REMARKS

DISCUSSION OF PRIOR ART

FIG. 2

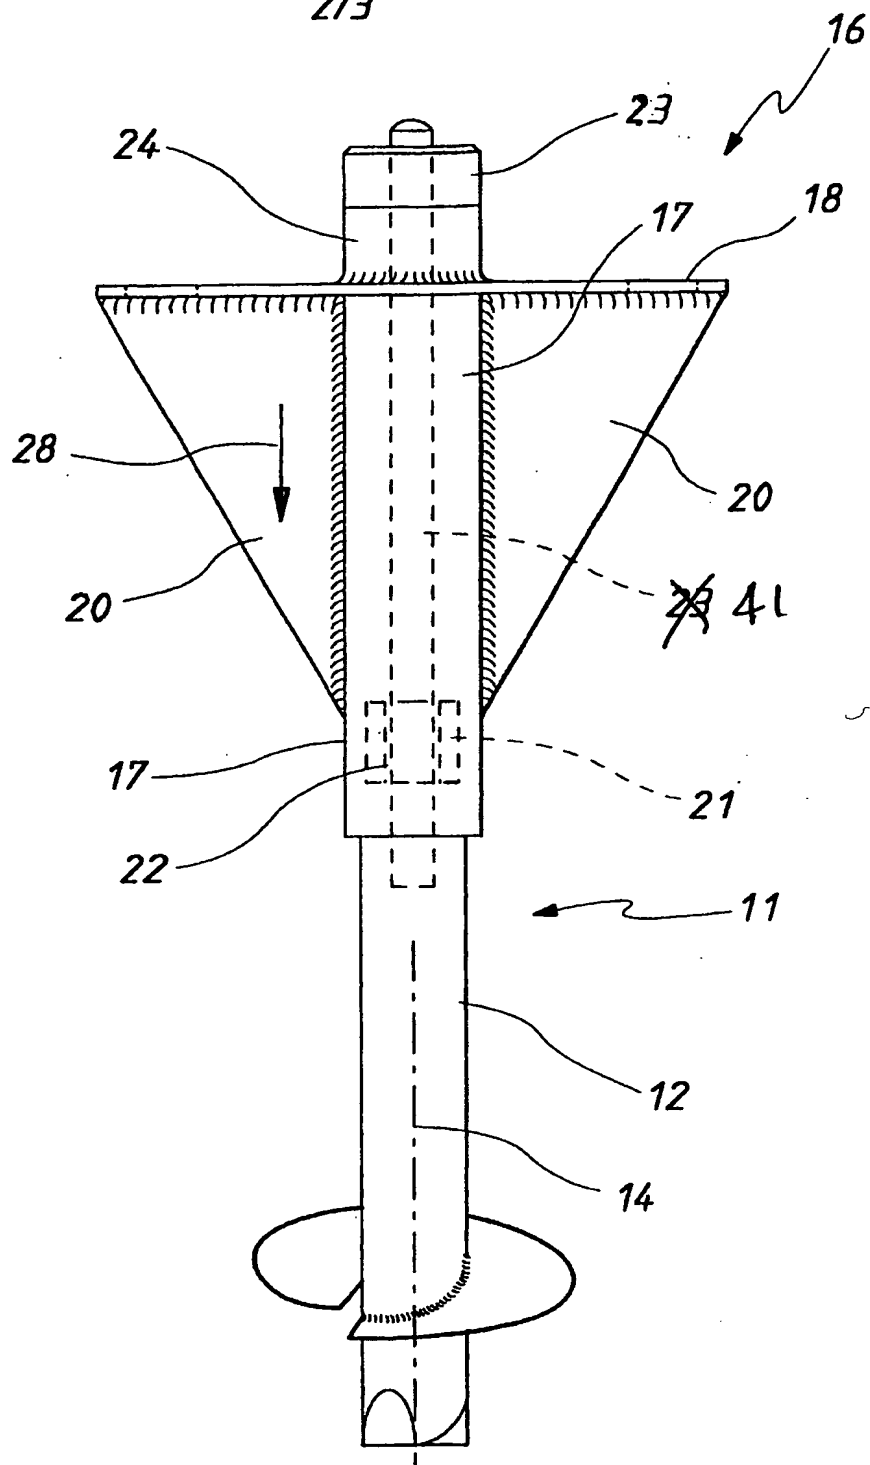
REPLACEMENT SHEETS of Figs. 1 and 2 are attached to add reference character 27 to Fig. 1 and replace a reference character 23 in Fig. 2 with 41 in correspondence with amendment of page 3 of the specification above and Annotated Sheets attached.
